SIB 32 03 23

RECALL 23V-XXX: STEERING WHEEL GROUND CONNECTION

This Service Information Bulletin (Revision 1) replaces SI B32 03 23 **dated October 2023**.

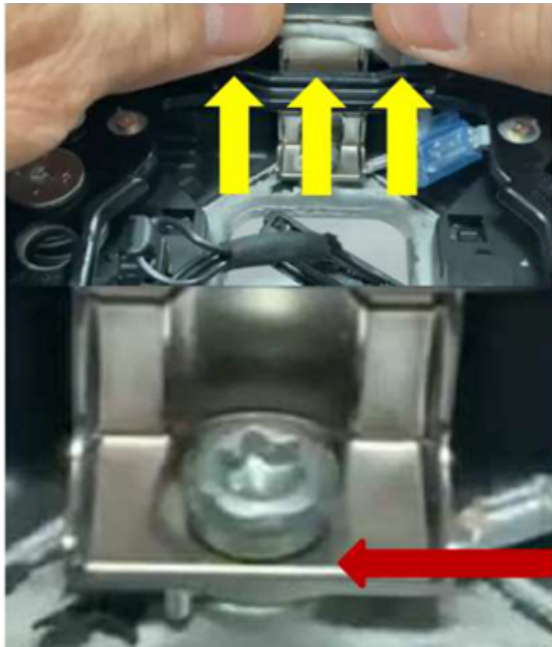
2. Remove the steering wheel airbag following the repair instructions listed in ISTA/AIR 32 34 030 and check the ground connection.

3. If the ground connection screw is not in contact with the horn plate bracket upon visual inspection but is tight and at the correct torque spec (2.5 Nm +/- 5 Nm), the screw must be removed, and the threads need to be inspected for any burr formations.

4. If the screw is already in full contact with the horn plate bracket and is tighten to (2.5 Nm + - 5 Nm), check the tightness of the connection as explained below.

Press the horn cover from the inside out to observe any possible movement of the horn pad bracket and the screw.

5. If there is no relative movement, use a 0.1 mm feeler gauge between the bottom of the screw head and the horn pad bracket.

Add two (1 mm) thick washers under the screw head, then tighten screw to (2.5 Nm +/- 5 Nm).
